RFI Questions and Answers (BOLLARD)

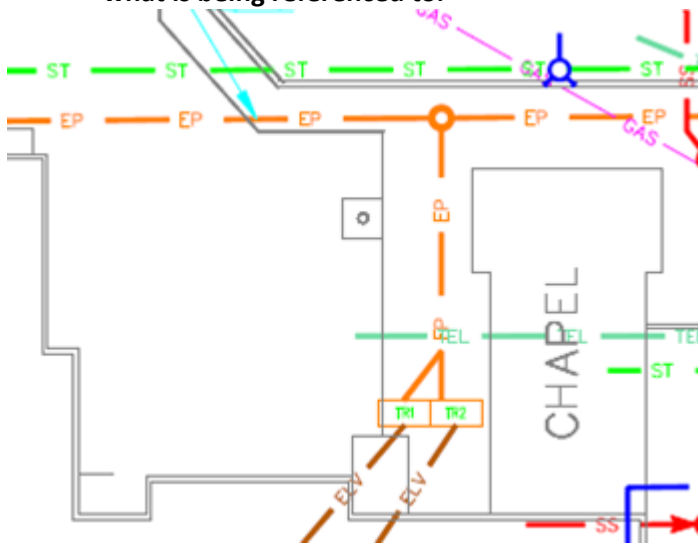
11. **Question:** Reference site utilities map (attached): The utilities map shows an unidentified structure in the path of the proposed bollards in the vicinity of the chapel. One person indicated it may be an underground electrical vault.

a. **Question:** What is the structure?

b. **Question:** How deep below the surface is the structure?

c. **Question:** We believe, if this structure or other hard feature is encountered, we should stop digging and set the bollard at the depth achieved. Please confirm.

Answer: This is an underground structure (Square with circle in center) we have no idea what it is. It's a 65 year old facility, looked through drawings available; there is no way to determine what is being referenced to.

Answer: See 11a above.

Answer: Yes.
